URGENT: FIELD SAFETY NOTICE – VT-RAP-19-02-001

EnCor® Breast Biopsy Probe
Impacted product codes/ lot numbers - Refer to Appendix 1

Figure 1: EnCor® Breast Biopsy Probe

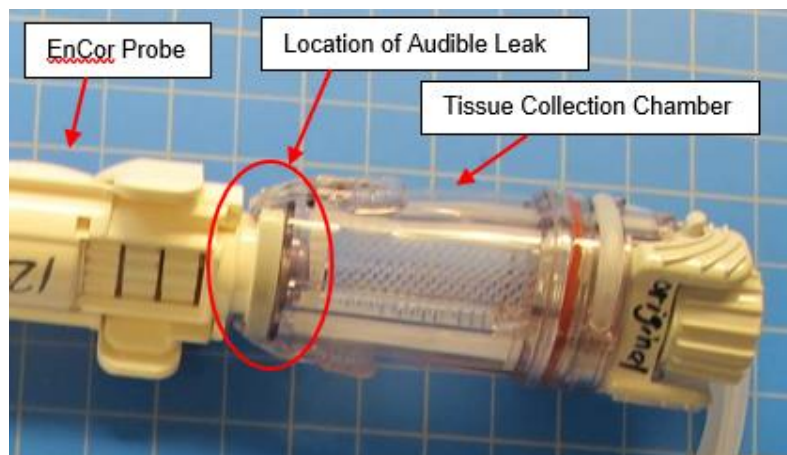
Based on customer feedback, BD has identified that the product codes/ lot numbers listed in Appendix 1, may be at risk of experiencing a leak at the location referenced in the figure above, which could result in:

1. The sample chamber filling with blood with the potential to leak onto the driver and/or driver gears during the procedure, and/or
2. Minimal suction which has the potential to result in a minimal or no tissue sample obtained.

1. After calibrating the ENCOR® Breast Biopsy Probe, press and hold the VAC button on the ENCOR® Breast Biopsy Driver or the VAC button on the foot pedal. Inspect the probe and listen for any abnormal hissing sound at the connection between the ENCOR® Breast Biopsy Probe and the Tissue Collection Chamber.

2. If any abnormal hissing sound is heard, gently rotate the Tissue Collection Chamber a quarter turn in either direction until the hissing sound abates.

3. If the hissing sound remains, remove the Tissue Collection Chamber by depressing the wings on the chamber body and pull back on the Tissue Collection Chamber. Then reconnect the Tissue Collection Chamber by gently pushing it back on the ENCOR® Breast Biopsy Probe until the wings click back onto the probe body.

4. If the hissing sound is still present, replace the device and repeat the steps above. If the issue persists, please contact your local BD representative.
